**Meeting of the Central Valley Flood Protection Board  
January 23, 2015**

**Staff Report**

**Union Pacific Railroad Bridge (No. 143.71) Replacement, Sutter County**

FACILITY: 8-SPAN 30" PCB x 240' REPLACING 34-SPAN TST-BD x 511'

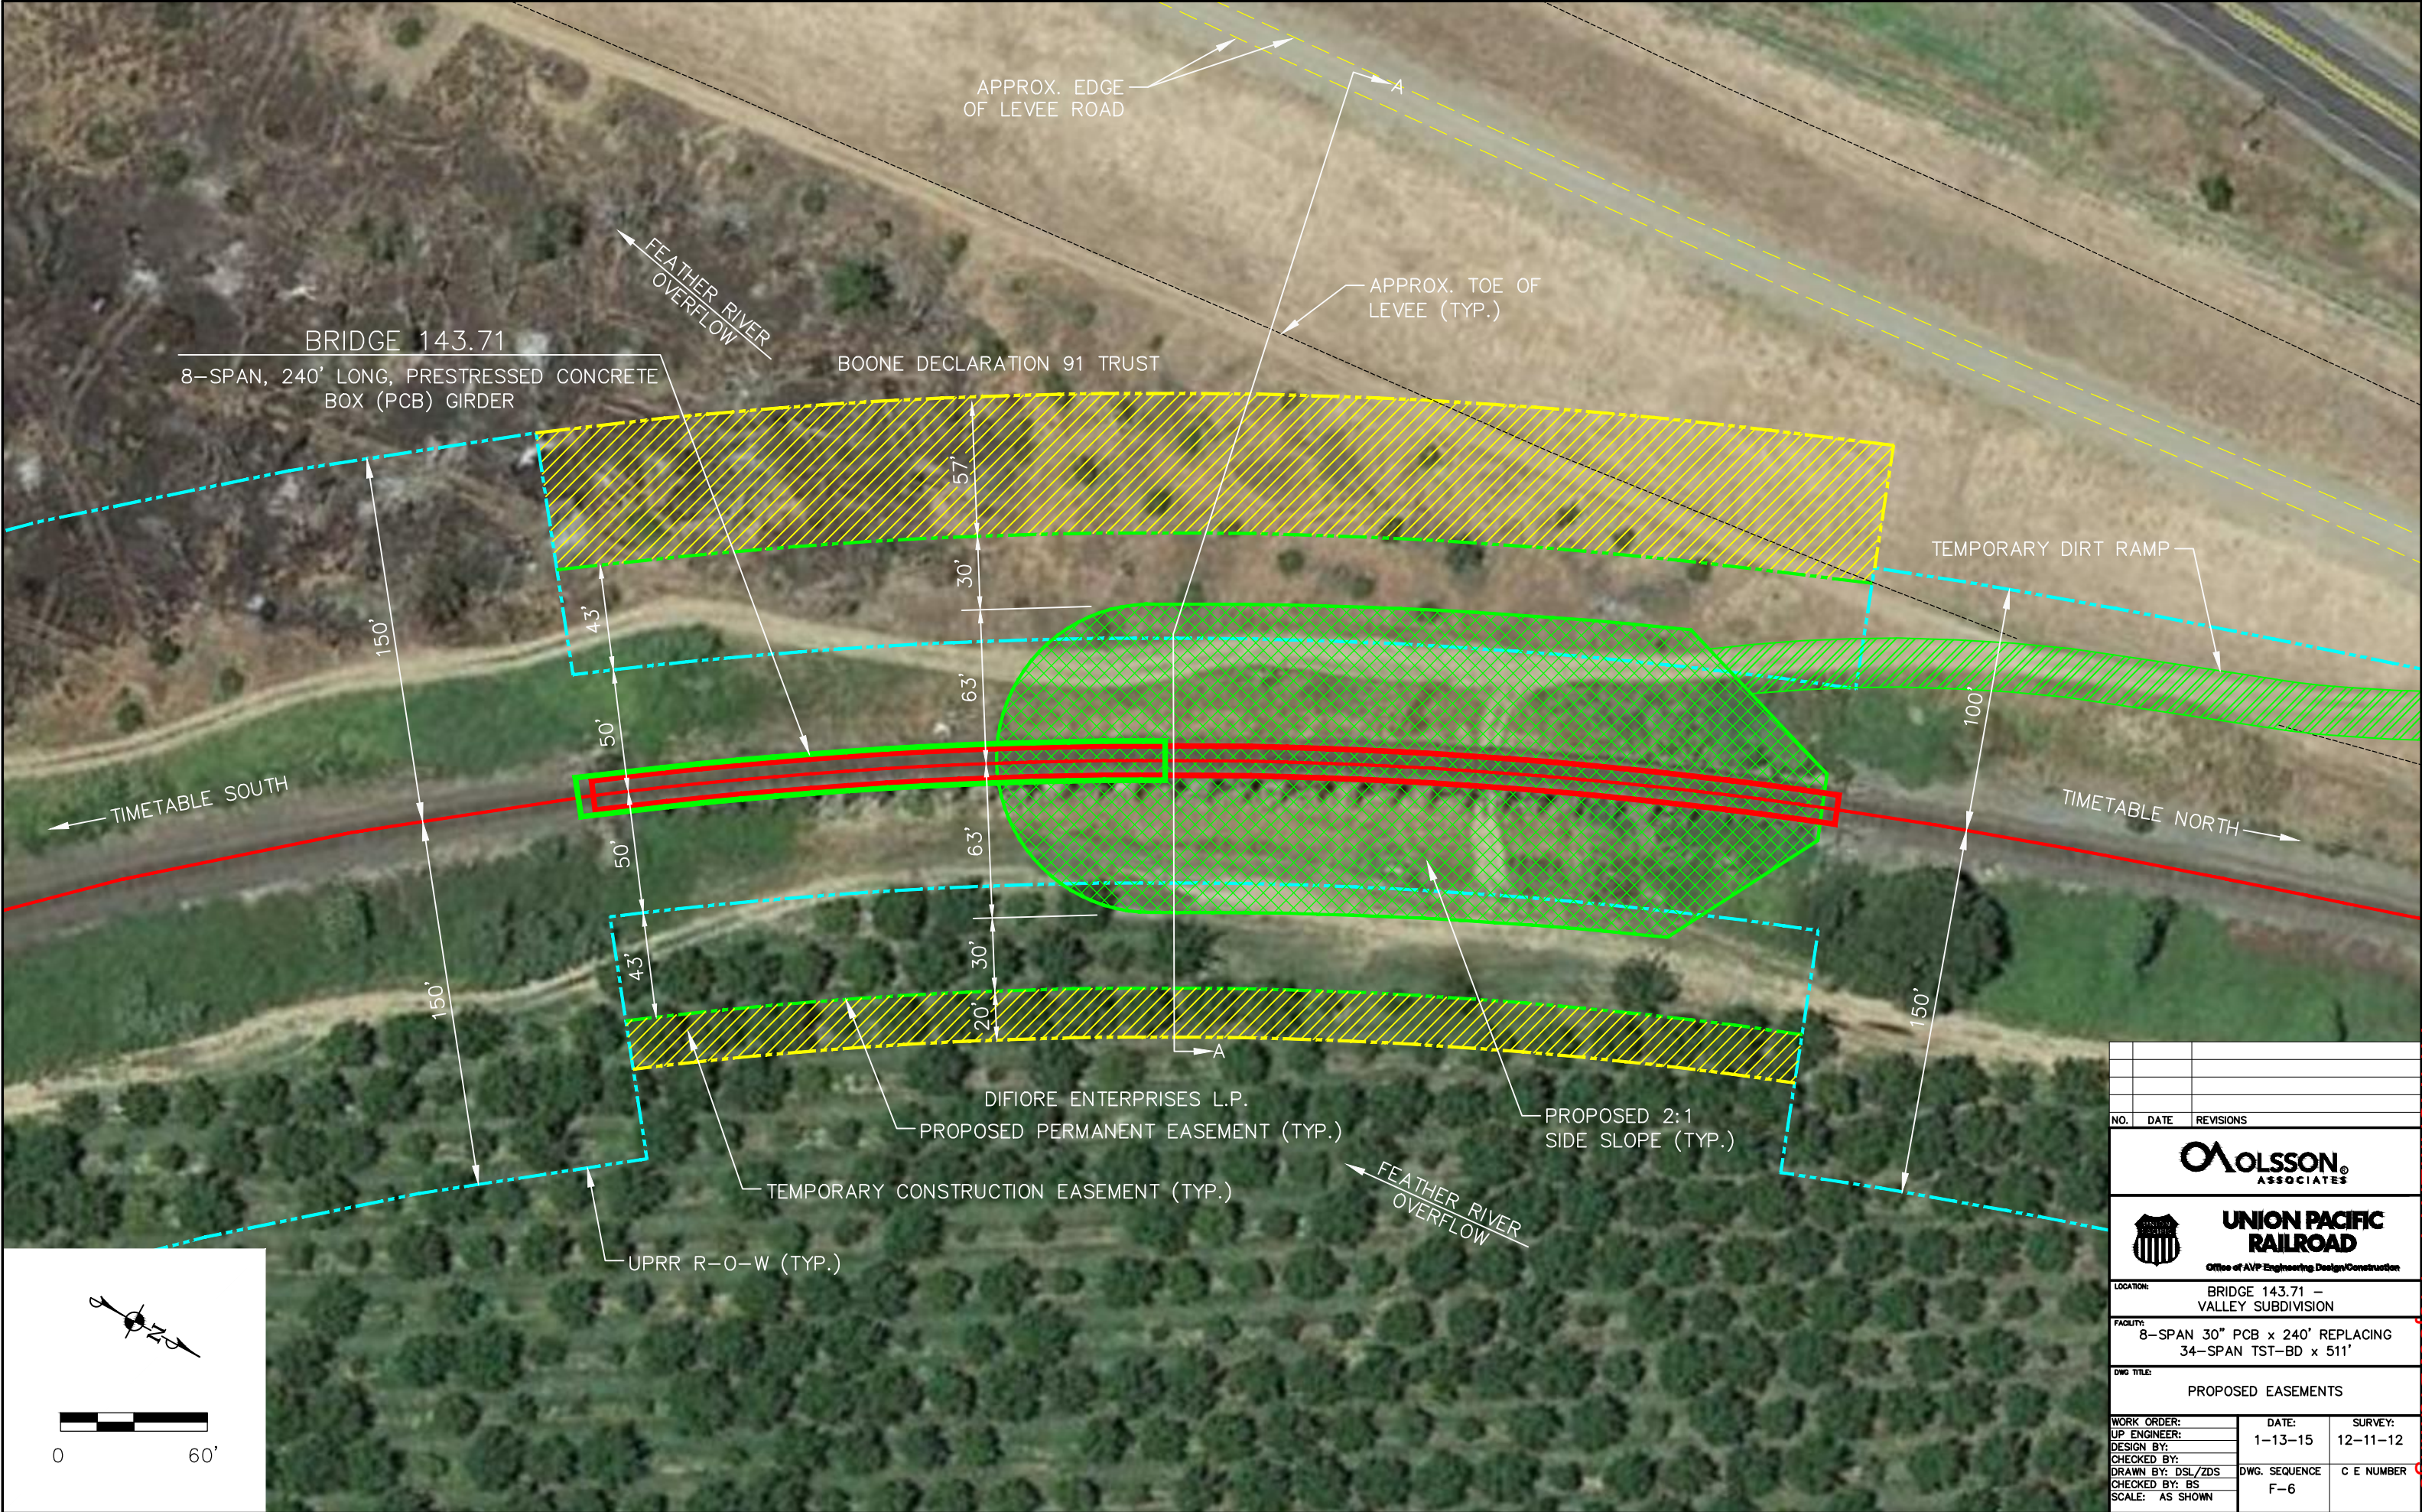
LD1's conditional approval (see Section 6.0) requested the UPRR to modify its bridge design in order to achieve zero computed WSE increase. In response to this request UPRR modified its design by adding one additional span at the southeastern end of the concrete bridge section. This modification replaces a portion of the existing railroad embankment currently blocking the floodway with an additional 30-foot width of open bridge to convey flood flows. The increased floodway conveyance offsets all prior computed increases in WSE based on the initial bridge design, and satisfies the requirements of LD1's endorsement Condition No. 8 that the new bridge result in no WSE increase.
